## DFCM Addendum #1

**Reference:** Zions Building Kitchen Update  
Utah State Fairpark  
DFCM Project #25266370  
U3P Event #DA25040

# ADDENDUM NO. 1

## FAIRPARK ZION'S KITCHEN

Sheet Number  
**A114**

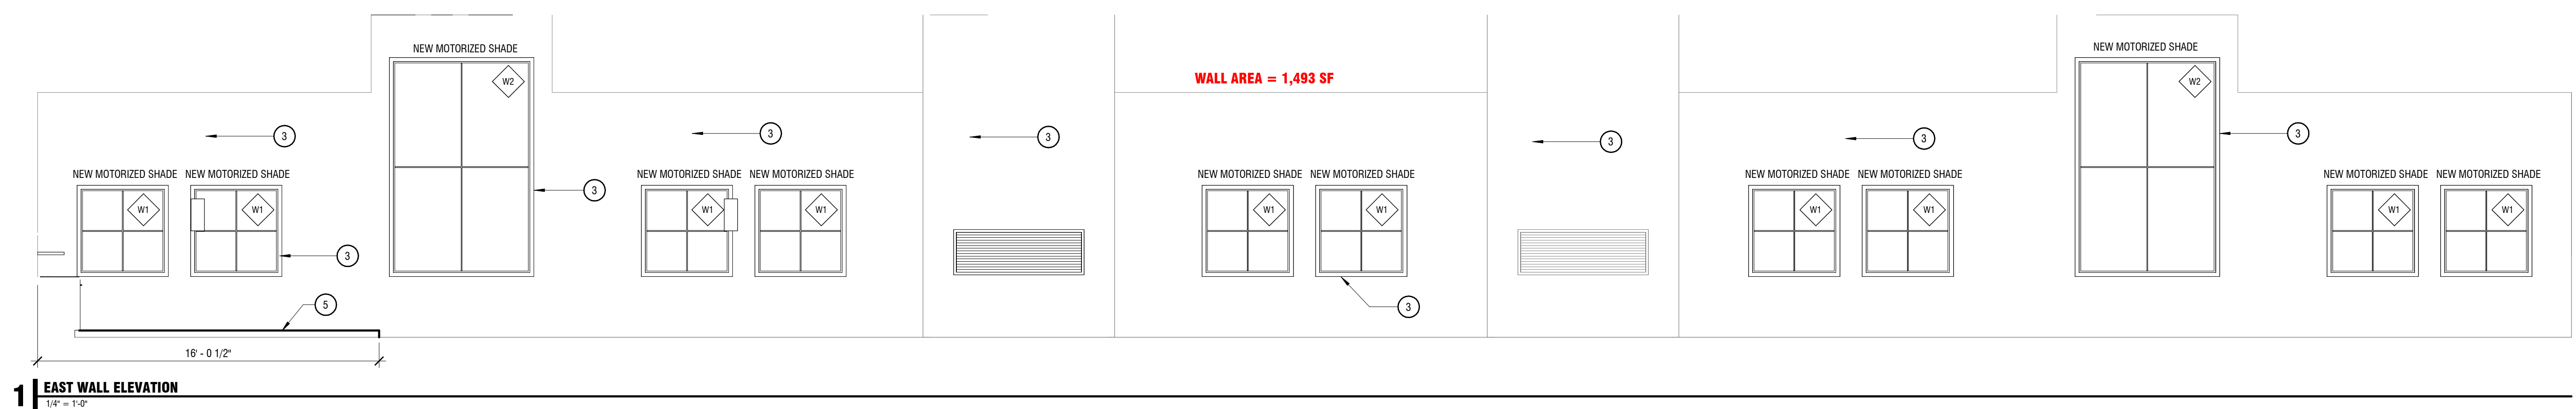
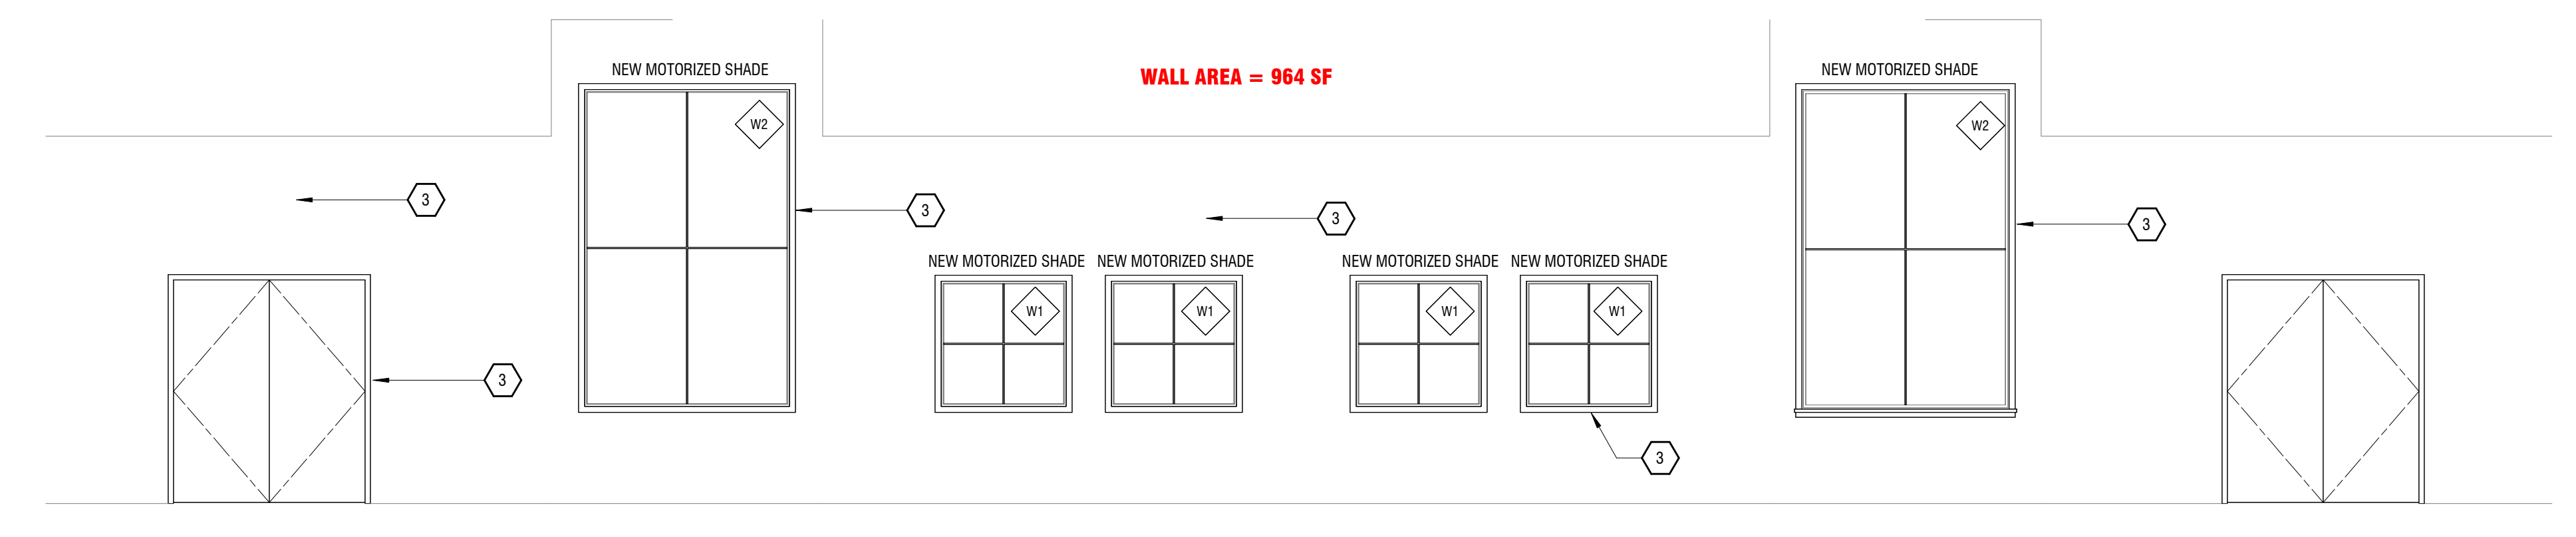
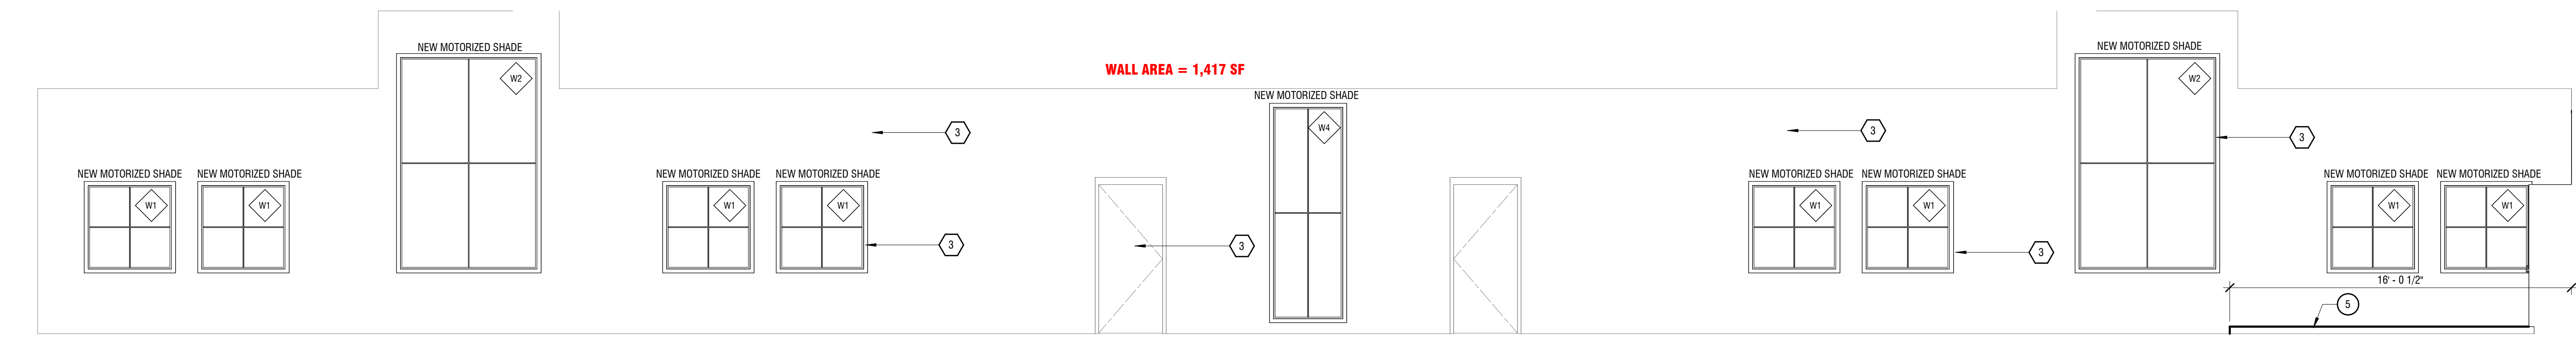
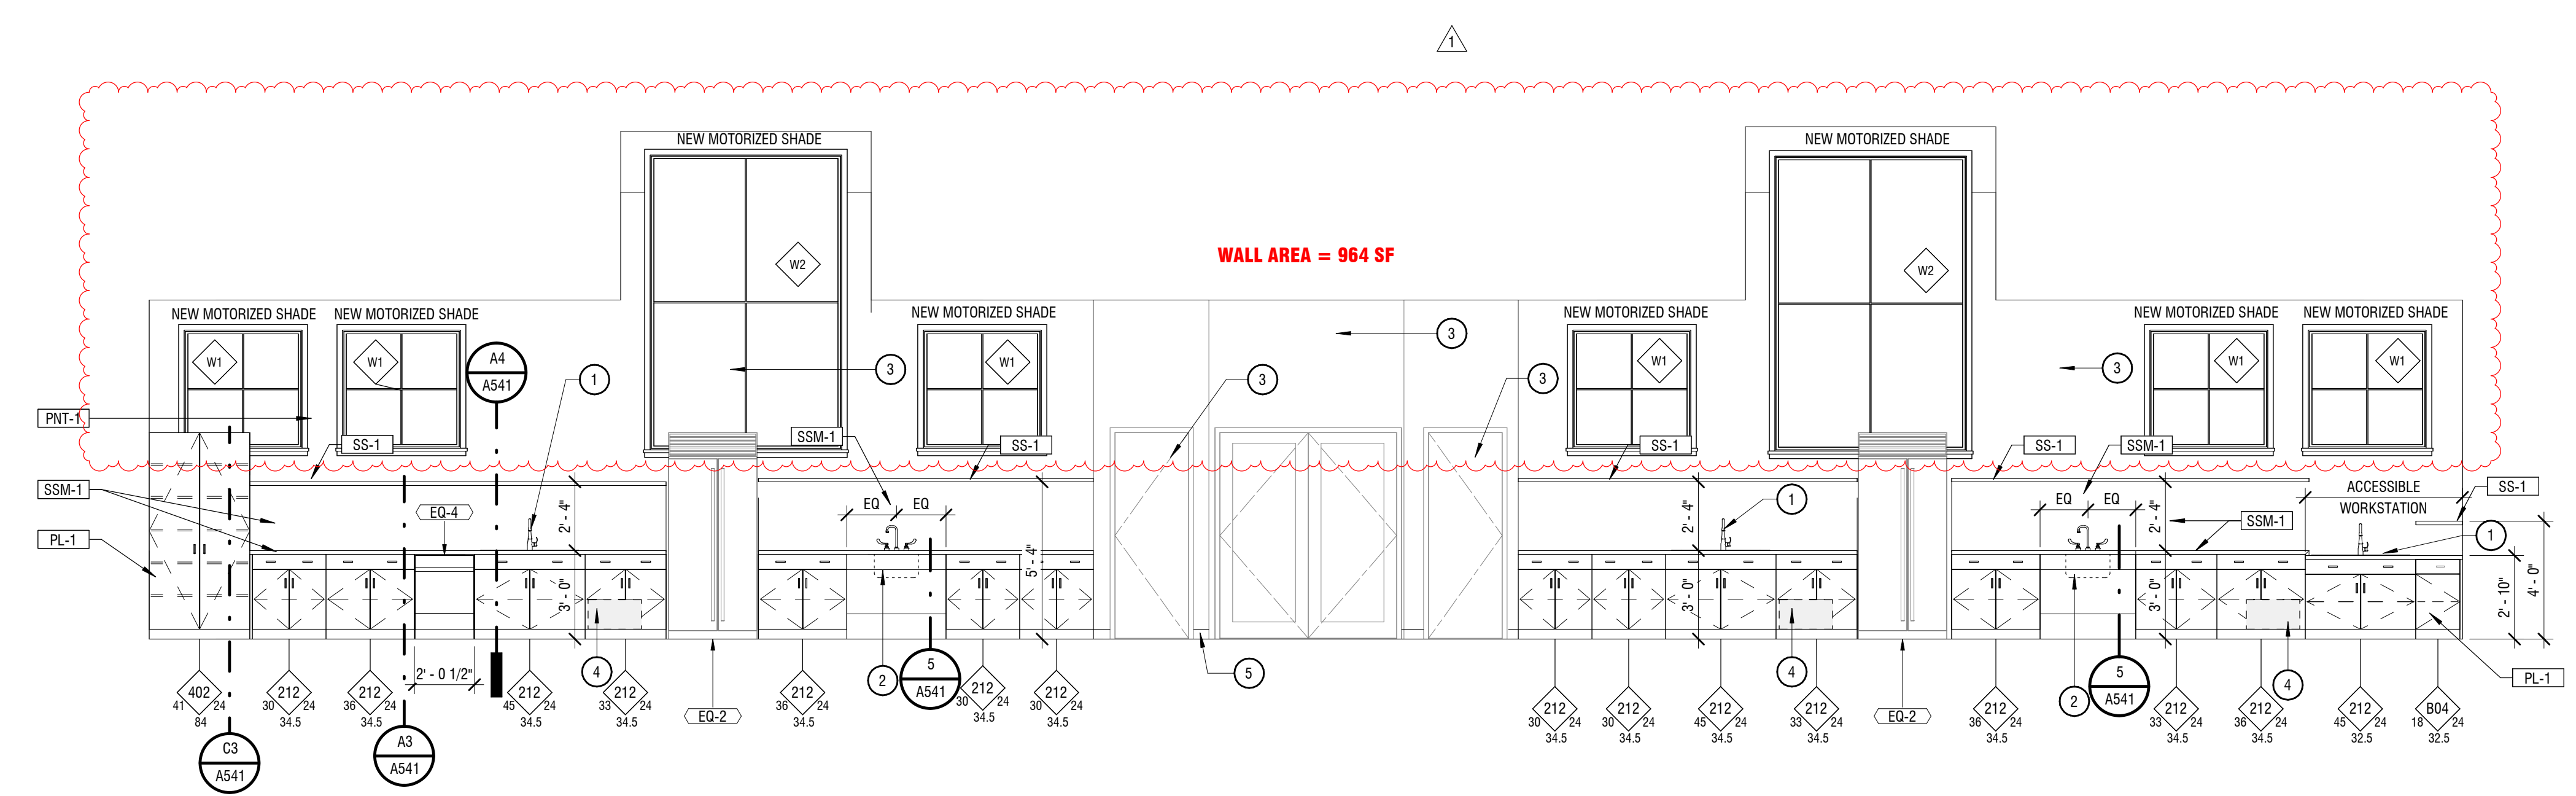
1. Civil
  - a. NA
2. Landscape
  - a. NA
3. Architectural
  - a. AD101 – Remove concrete at existing waste line to expose and replace the existing line.
  - b. A112, see revision adding patch and repair to the concrete floor.
  - c. A112- extend extent of epoxy floor and base to grid line B
  - d. A114 – Add widow shades to the north windows.
4. Structural
  - a. NA
5. Mechanical/Plumbing
  - a. Toilet Rooms – Replace the instantaneous water heaters using the existing location and voltage and phase. Contractor to circuit trace each water heater back to the panel. To establish the voltage and the KW size requirement. The water heater with same make as the kitchen water heaters.
6. Electrical
  - a. EP100 - See narrative attached drawings
  - b. EP101- See narrative and attached drawings
  - c. EP601- See narrative and attached drawings
7. Other
  - a. None

3. Is the electrical to the motorized window shades to be surface mounted? Or would you like us to trench and repair the walls to conceal the electrical?

Response: All electrical related to the shades will be surface mounted.
